Subject: Zion Station Units 1 and 2
Additional Information on Proposed
Expansion of Spent Fuel Storage Capacity
NRC Docket Nos. 50-295 and 50-304

SPENT FUEL POOL CAPACITY EXPANSION

ROUND 2 QUESTIONS

ROUND 3 QUESTIONS

Figure 3. 1-D Supercell Configuration for First Benchmark Calculations

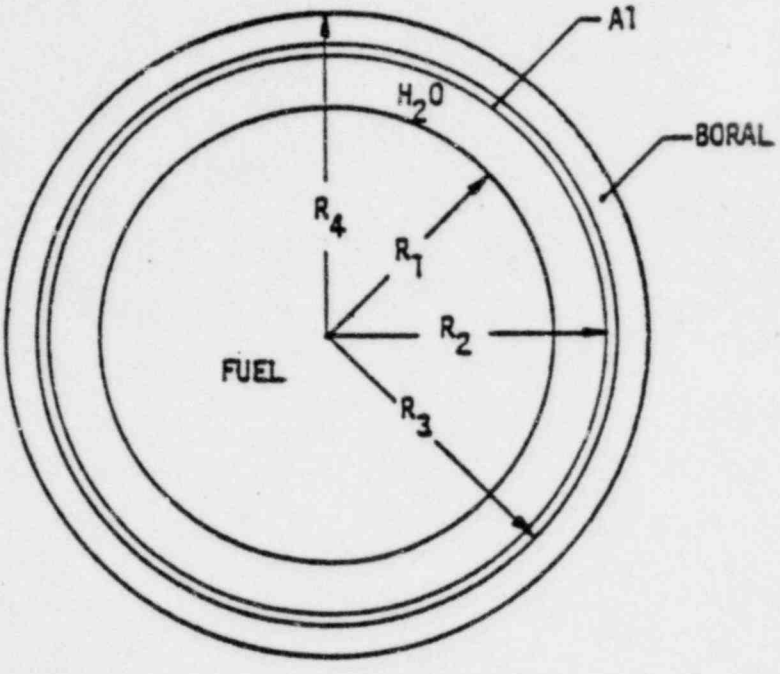
In regard to your response number 21, state the bases for the dimensions of the cylindrical supercell (Figure 3) for the first benchmark calculation.

Radii R_1 and R_2 of the cylindrical supercell (Figure 3) is obtained by conserving the corresponding areas of the 9 x 9 basic fuel pin assembly. Radius R_3 is obtained by adding the aluminum wall thickness to the fuel pin assembly and then conserving the area. Radius R_4 is obtained by adding to R_3 half the thickness of the boral core.

Constants used for cylindrical supercell dimensions:

Basic fuel pin assembly array	=	9 x 9
Fuel rod pitch	=	0.75 inches
Thickness of AL wall	=	.041 inch
Thickness of boral plate	=	0.168 inch
Thickness of water layer	=	½(0.75-2x0.041-0.168)
	=	0.25 inch

$$= (\text{fuel rod pitch} \times 9)^2$$
$$= (0.75 \times 9)^2 \text{ sq. in.}$$
$$= (6.75)^2 \text{ sq. in.}$$
$$= (6.75 \times 2.54)^2 \text{ sq. cm.}$$
$$= 293.95102 \text{ sq. cm.}$$
$$= \pi R_1^2$$
$$R_1 = \left(\frac{293.95102}{\pi}\right)^{\frac{1}{2}} \text{ cm.}$$
$$= 9.67303 \text{ cm.}$$

$R_4 = R_3 + \frac{1}{2}$ thickness of boral plate

$= 10.09005 + \frac{1}{2} \times 0.163 \times 2.54$

$=$ 10.30341 cm.

Figure 1

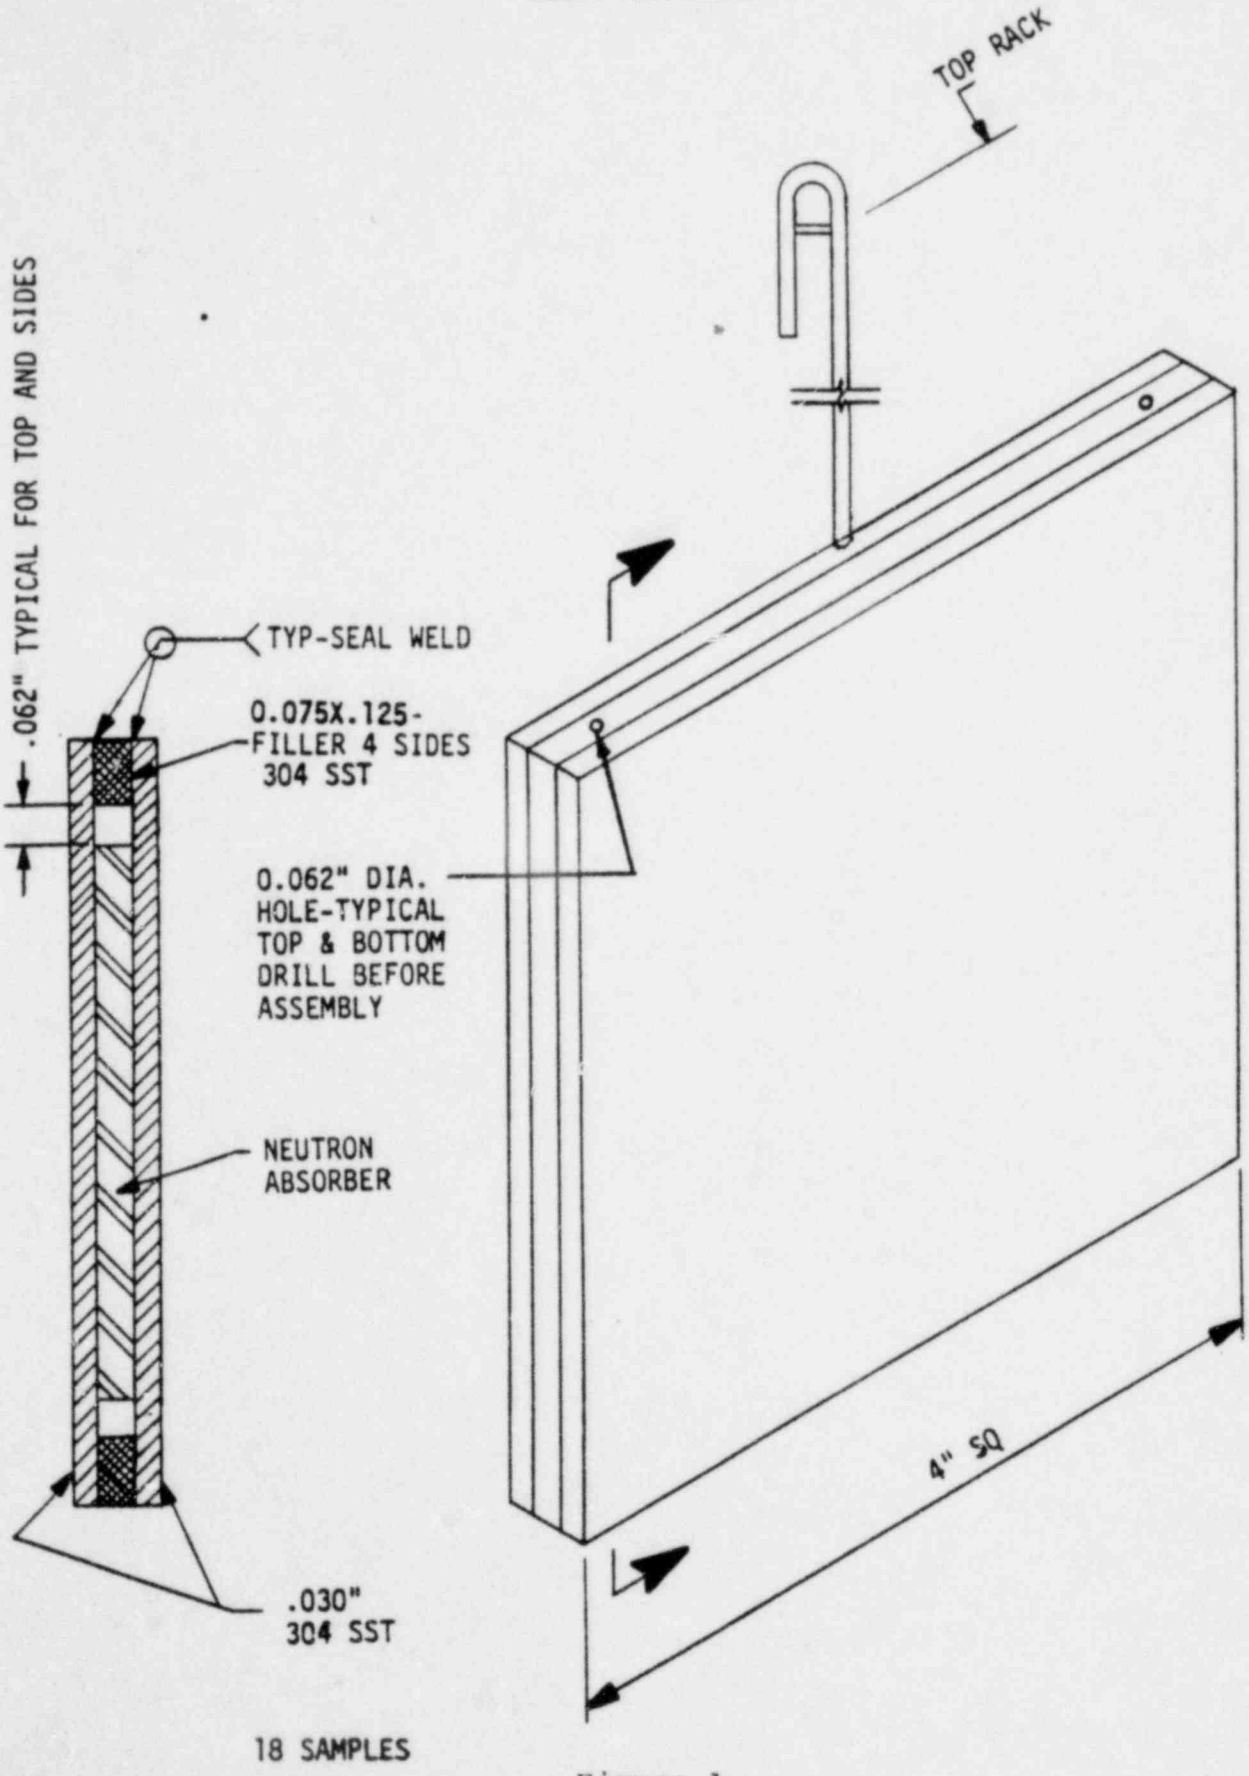
For the proposed type of racks, a surveillance program is required to show the continued presence of boron throughout the life of the racks. Provide a description of the boron surveillance program that you will perform.

A sampling plan to verify the ability of a neutron absorber material employed in the high density fuel racks to withstand the long-term environment is described.

The test conditions represent a restricted flow of water over the neutron absorber material. The samples will be supported adjacent to and suspended from the fuel racks. Eighteen (18) test samples are to be fabricated in accordance with Figure 1 and installed in the pool when the racks are installed.

1. Samples shall be cut to size and dried in an oven for five hours at 175°F, followed by a cycle at 600°F for three hours.
2. Samples shall be weighed immediately following removal from the oven and weight in milligrams recorded for each sample.
3. Samples shall be fabricated in accordance with Figure 1 and installed in pool.
4. Two samples shall be removed per schedule shown in Table 1.
5. Carefully cut samples apart at the weld without damaging the neutron absorber. Wash with a soft brush in a mild abrasive and detergent solution, immerse in nitric acid to remove surface products, followed by a rinse of clean water and alcohol. Dry in a 175°F oven for five hours, followed by a cycle at 600°F for three hours.
6. Weigh the samples and evaluate the weight change in the neutron absorber material in milligrams per square centimeter per year.

FIGURE 4.1 LUMPED MASS STICK MODEL FOR SLIDING ANALYSIS

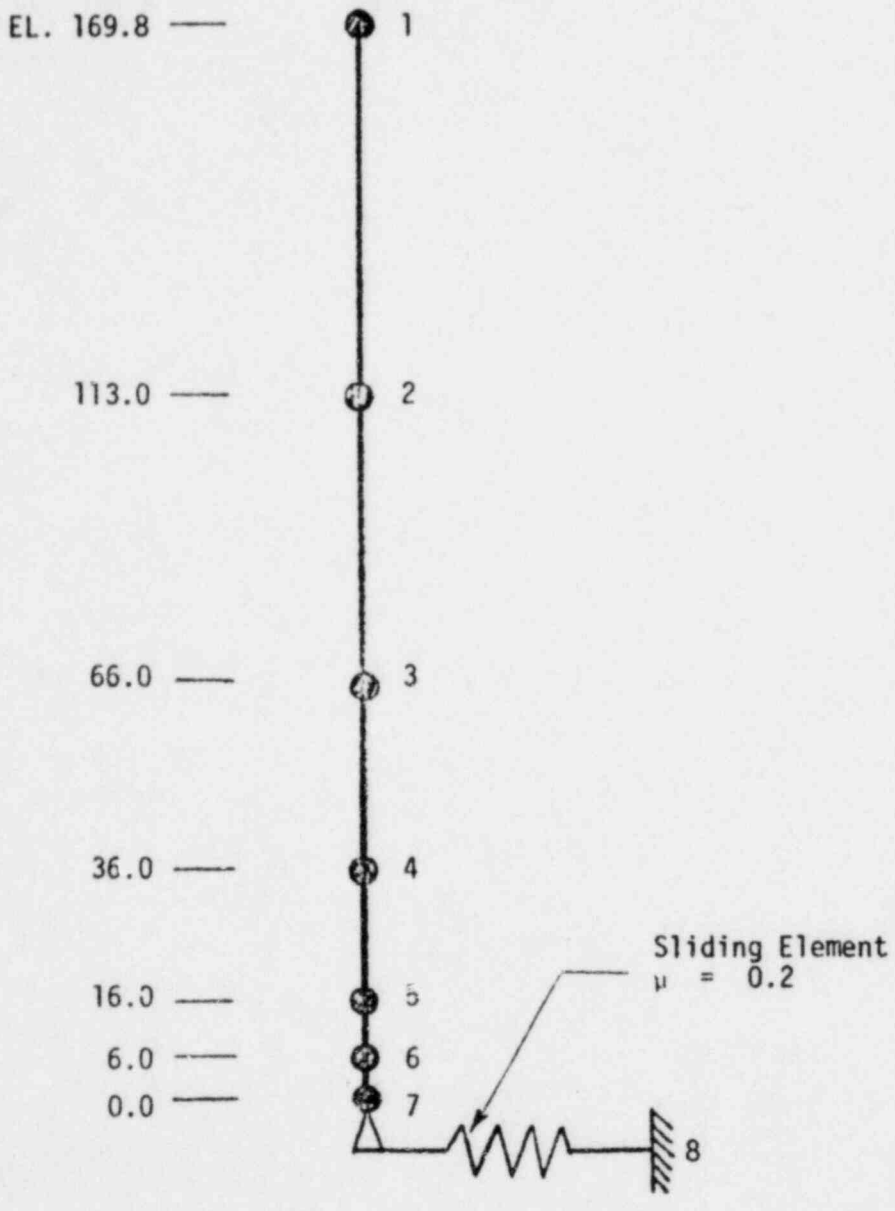
Provide the basis for concluding that an empty rack will slide further than a full rack under seismic loadings. Provide a drawing of the equivalent stick model used in the sliding analysis and indicate the points where these loads were applied.

Since the spent fuel racks are stored under water, their seismic movements are caused by the horizontal inertia of "virtual mass" which is the sum of the body mass and the "hydrodynamic mass". The magnitude of the hydrodynamic mass depends on the shape of the rack body and the density of water, and so is independent of whether the rack is loaded or empty. The friction force resisting the seismic movement is proportional to the buoyant weight of the rack and its contents, but because of larger horizontal "virtual mass" per unit weight, the ratio of inertia force to friction force is more for empty racks. For this reason, it was concluded that empty racks will slide further than a loaded rack under seismic loadings.

Figure 4.1 shows the equivalent stick model used in the sliding analysis. Time history of SSE seismic movement was applied at Node 8 which represents the pool floor.

FIGURE 6.1 MATHEMATICAL MODEL FOR THERMAL (Q) ANALYSIS

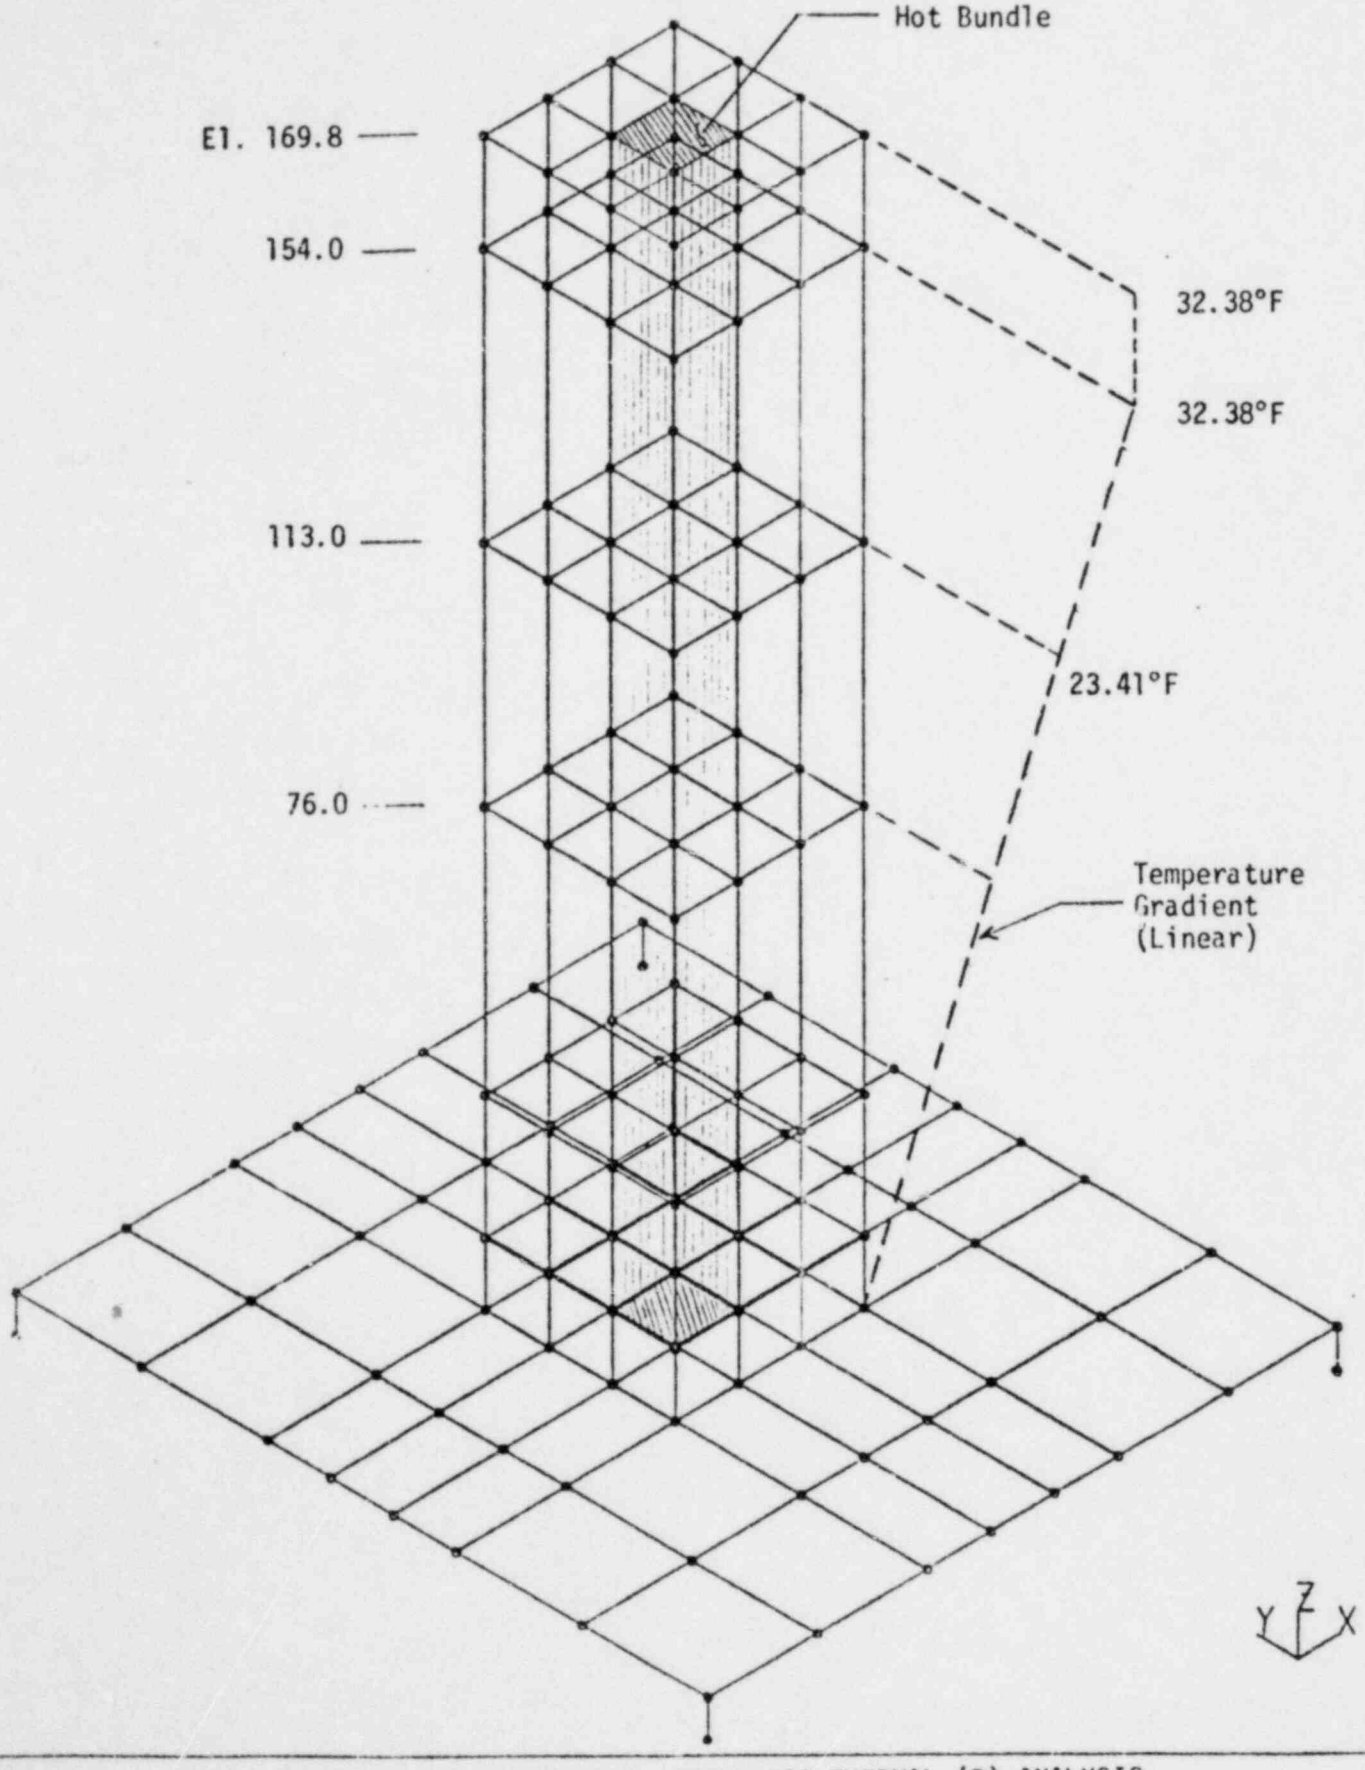
Provide a description of the thermal gradient analysis considerations, include the thermal gradient considered and a discussion on why this was considered a conservative estimate of the worst case, i.e., the gradient between a full and empty cell.

The thermal gradient due to the placement of a hot fuel bundle in an empty rack is as shown in Figure 6.1 (0°F at the rack bottom and 32.38°F at the top). Stresses caused by this thermal gradient were computed using a finite element model which is also shown in Figure 6.1. To minimize the computation cost, only the central part of the rack body was modeled with the sides restrained from lateral translation, thus representing the worst case and predicting conservative stresses. It is important to note here that, near the top of the rack the thermal gradient, and hence, the resulting thermal stresses are maximum, but the dead load and seismic stresses are minimum. Thermal gradient near the bottom is very small where the seismic and dead load stresses are maximum.

FIGURE 7.1 SPENT FUEL RACK SHOWING CRITICAL LOCATION OF POSTULATED FUEL BUNDLE DROP

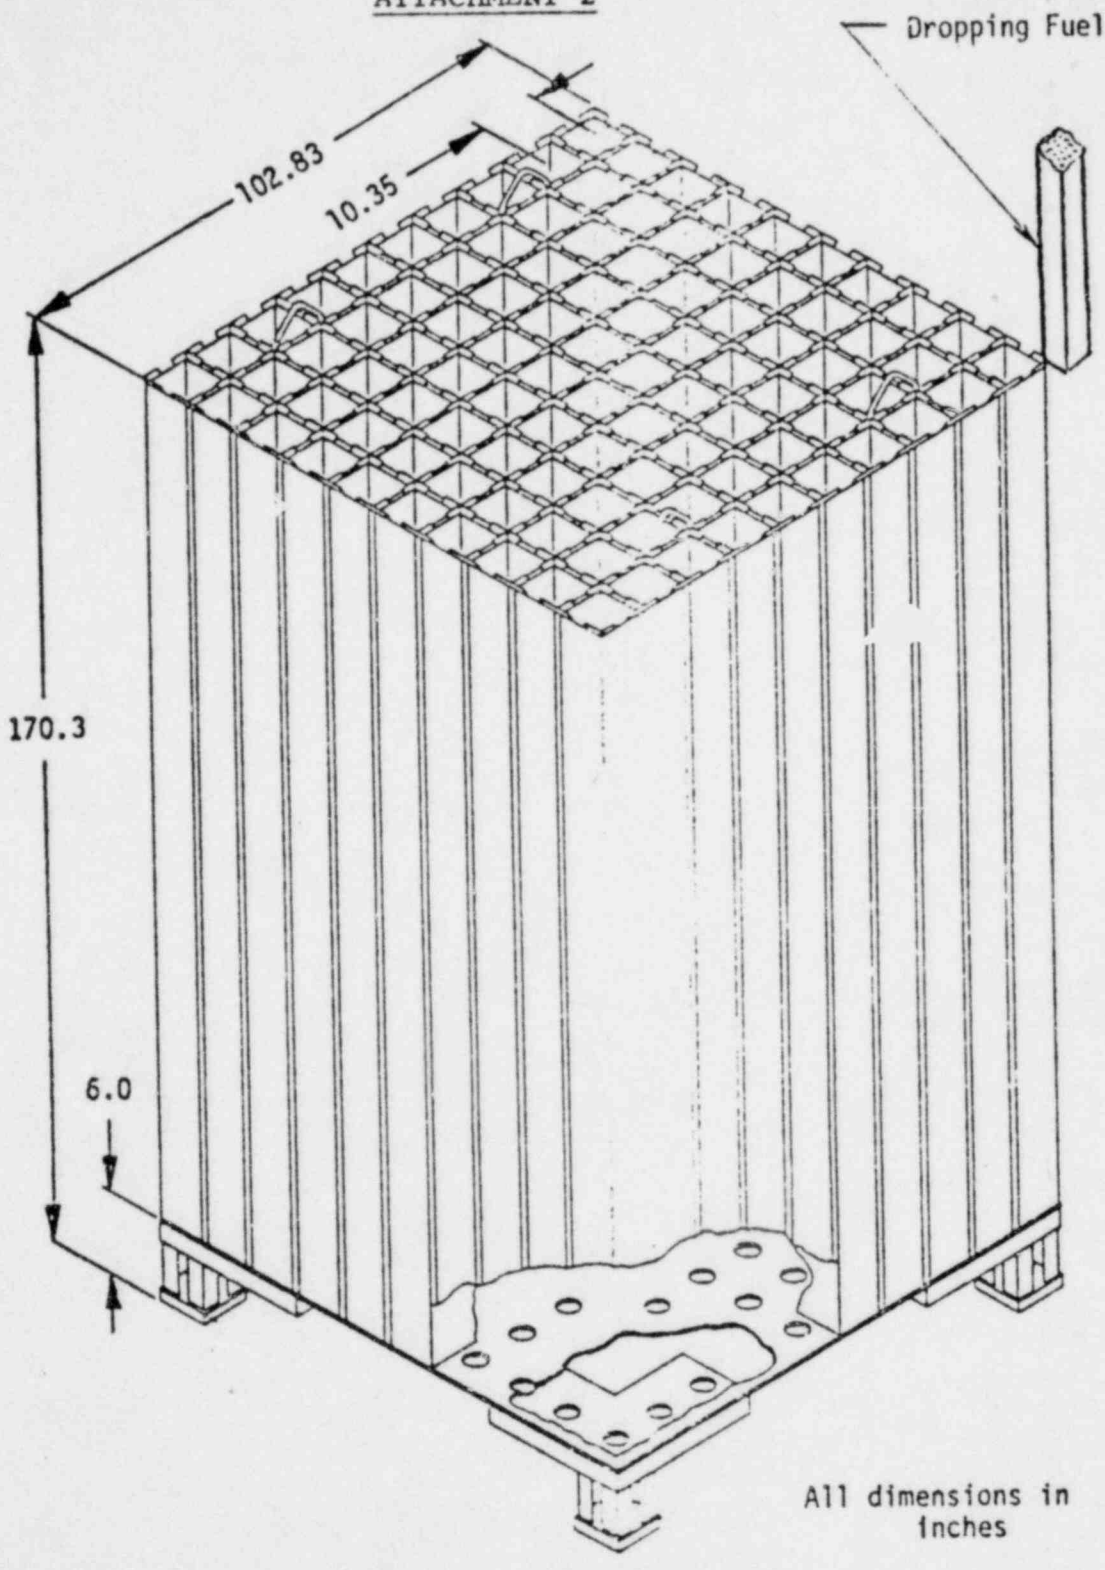
The fuel bundle drop analysis considered a drop at the most "critical" location on the rack, provide a description of this location and drawings to illustrate the postulated configuration of the fuel bundle at impact. Discuss the procedure for limiting the height of the fuel bundles above the racks to 24 inches. Discuss the consequences of a fuel bundle dropping straight through the tube and impacting the bottom of the rack.

The top corners of the racks were found to be the most critical locations for evaluating the consequence of dropping a fuel bundle. When the fuel bundle drops on the rack, the cross-sectional area of the cell walls absorbing the impact energy increases as the load is transmitted downward. Since this gradually-increasing cross-sectional area is minimum when the fuel bundle drops on a corner, the latter constituted the most critical location.

For evaluating the consequences of fuel bundle drop, the bundle configuration was assumed to be vertical at impact

(Figure 7.1). An inclined drop was judged to be less critical from the following considerations:

(a) The impact area will be larger,

(b) The impact will be "softer" because of the flexibility of the fuel bundle itself.
